Subject: Duke Power Company LLC d.b.a. Duke Energy Carolinas,
LLC

Catawba Nuclear Station, Units 1 and 2
Docket Nos. 50-413 and 50-414

License Amendment Request Revising Catawba, Units 1
and 2 Commitments to USNRC Regulatory Guide 1.82,
Revision 0, "Sumps For Emergency Core Cooling and
Containment Spray Systems" and Revising Technical
Specification Surveillance Requirement (SR) 3.5.2.8
and Associated Bases.

Figure 1: Current ECCS Sump Design Drawing

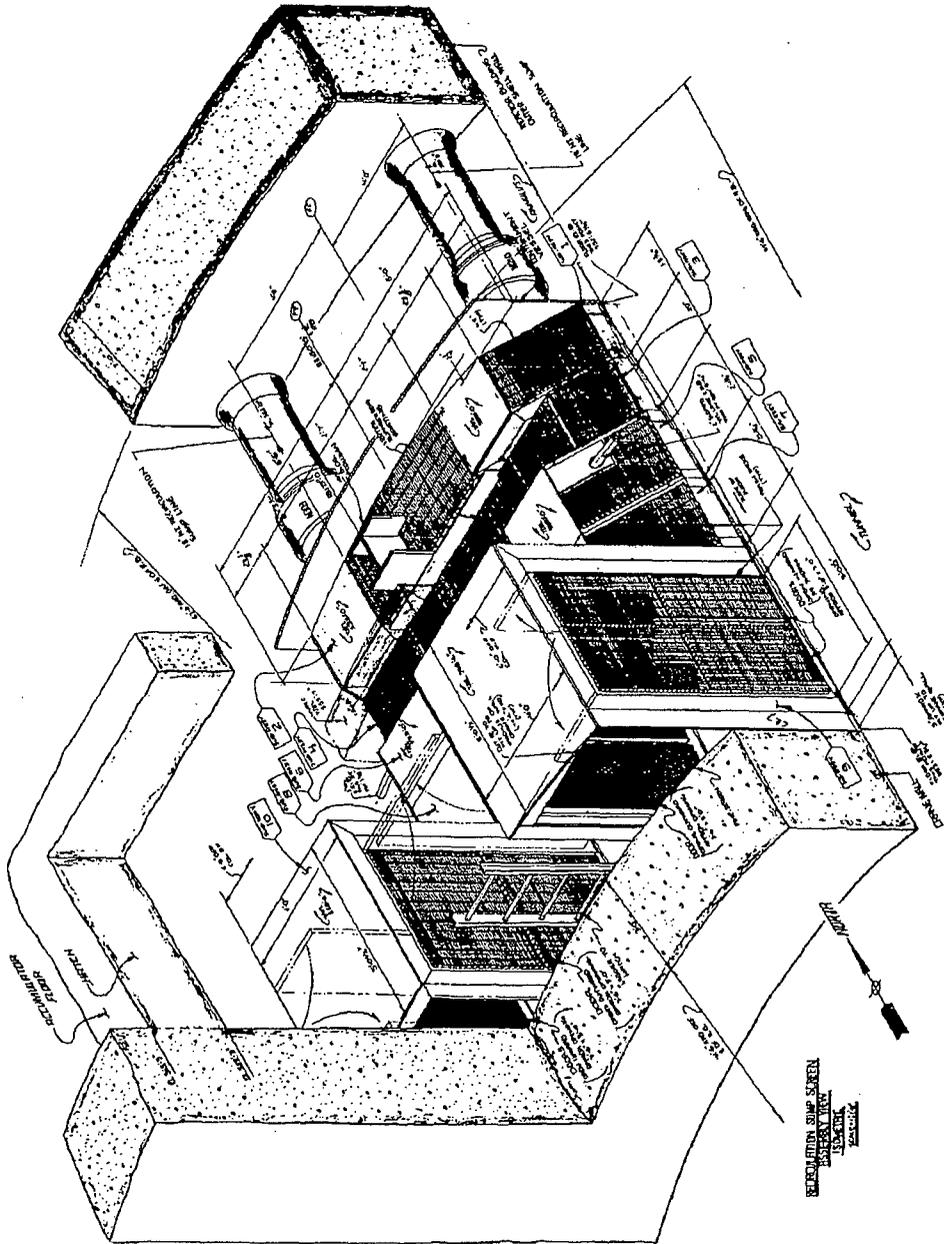
Each "sump" screen assembly consists of a horizontal solid top and filtering screen panels which extend almost to the floor. Above the ECCS intake pipe, the horizontal solid top of the screen assembly is at approximately 555' elevation. Beyond the ECCS intake pipe, the horizontal solid top extends slightly higher to approximately 558' elevation. The screen panels contain an outer trash rack which prevents large debris from reaching the inner fine screen. The fine screen prevents particles which are large enough to

impair ECCS or containment spray performance from being drawn into these systems. The fine screen mesh is sized to preclude any particle larger than 1/8" in diameter. This size is significantly smaller than the size needed to prevent clogging of the NS spray nozzles. The top of the screen assembly contains holes which are 1/8" in diameter. This feature ensures that the assemblies are self venting as the water covers the top. Sump Recirculation Screen performance, including the description of debris transport through the Containment, is discussed and evaluated in the Catawba UFSAR Section 6.2.2.2. A summary drawing of this structure also appears in the UFSAR, Figure 6-111. Reference Figure 1.

The Catawba modification removes the original ECCS Sump structure described above and replaces it with a structure consisting of tube modules (top-hats) made of stainless steel, having two layers of perforated plate for straining debris from the water. (Reference Figure 2.) The openings in the perforated plate do not exceed 3/32 inch diameter. The RHR/CSS recirculation lines are connected to the main plenum of the strainer assembly using 18 inch piping. Horizontal vortex suppressors will be installed above the top-hat strainer assemblies.

the RHR/CSS Pumps during the post-LOCA Recirculation Phase. The new strainer offers approximately 2000 square feet of surface area versus the original 135 square feet total for the original sump screens. When completed, the installation of the revised sump design is intended to resolve concerns associated with GSI-191. The changes made enhance the existing design by providing a larger surface area for the filtration of debris.

Figure 2 (b)

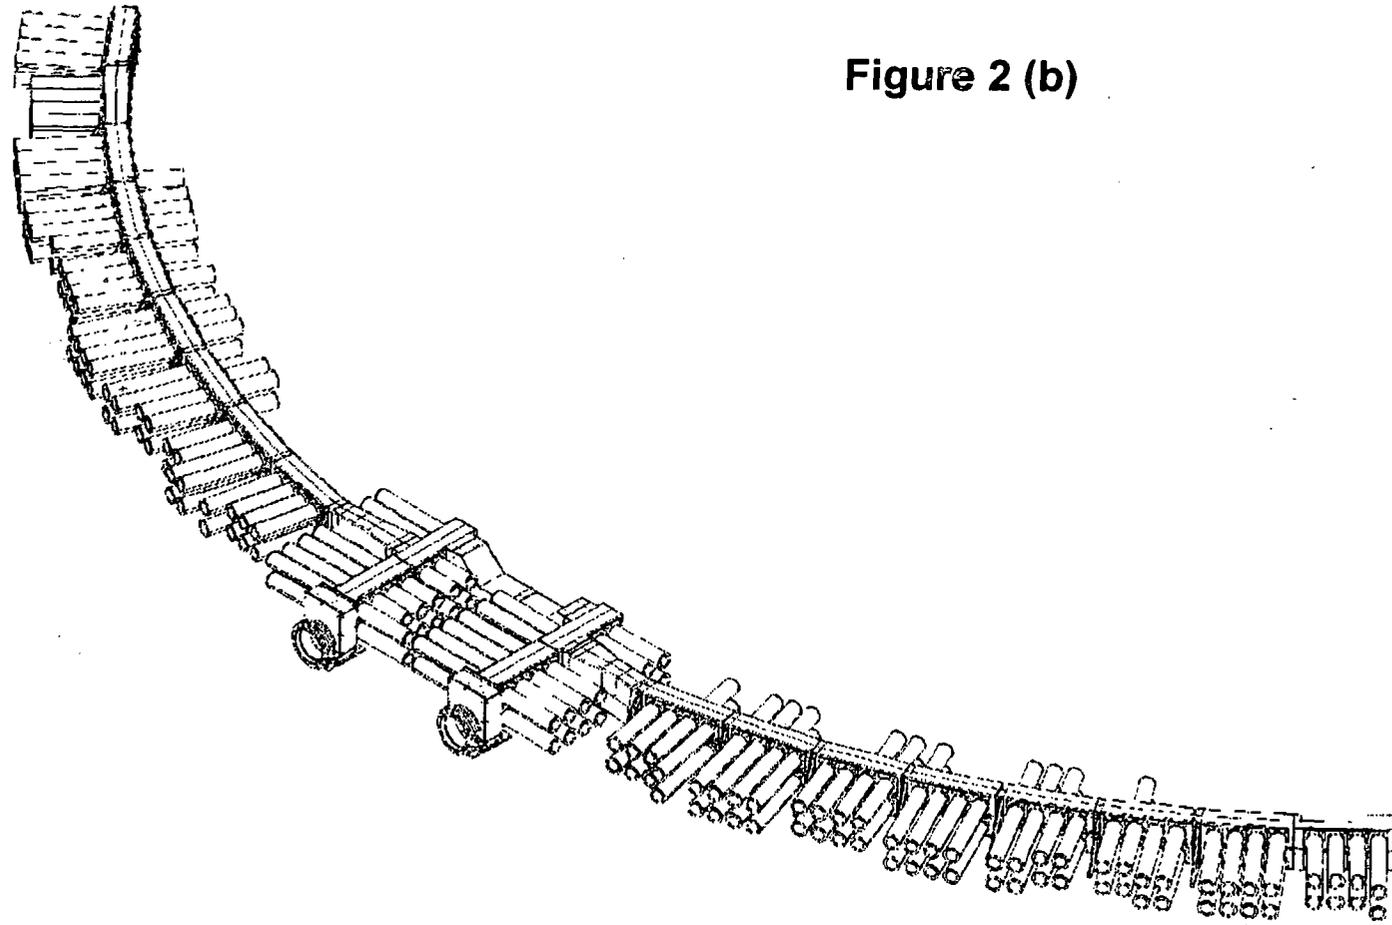
The Catawba strainer will be installed entirely inside the pipechase outside the polar crane wall. There are no pipe whips or water/steam jet loads projected to occur within the Catawba pipechase.
